## **BID ADDENDUM NO. 3**

May 16, 2018

Elmira City School District  
Ernie Davis Academy 2018 Additions & Alterations  
HUNT No.: 2012-211

SED #07-06-00-01-0-038-026

**AD3-A1**

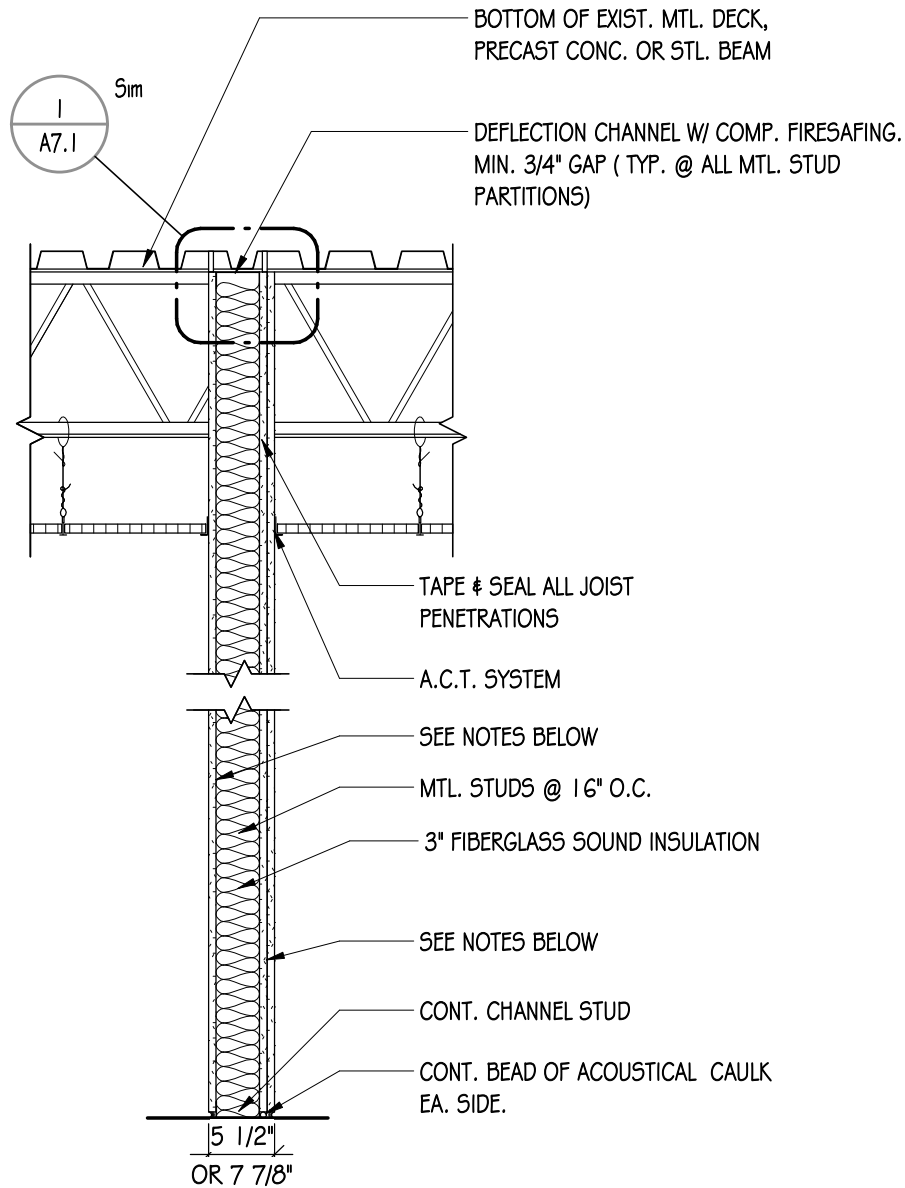
**ITEM AD3-4 Refer to Drawing A7.1, Partition Types & Details**

AMEND Partition Types 2, 2A, 2B & 2C as shown in drawing AD3-A1 as issued by this addendum.

| <b>2</b>  | (2) LAYERS 5/8" HIGH IMPACT GWB CORRIDOR SIDE<br>& (1) LAYER 5/8" HIGH IMPACT GWB OTHER SIDE ON<br>3 5/8" MTL. STUD; UL #U425 (1 HR RATED) |
| <b>2A</b> | SAME AS TYPE 2, W/ 6" MTL. STUD; UL#U425   |
| <b>2B</b> | SAME AS TYPE 2A, (2) LAYERS 5/8" HIGH IMPACT GWB<br>EA. SIDE; UL#U425 (2 HR RATED)   |
| <b>2C</b> | SAME AS TYPE 2, W/ (1) LAYER 5/8" HIGH IMPACT GWB<br>EA. SIDE; NO UL #   |
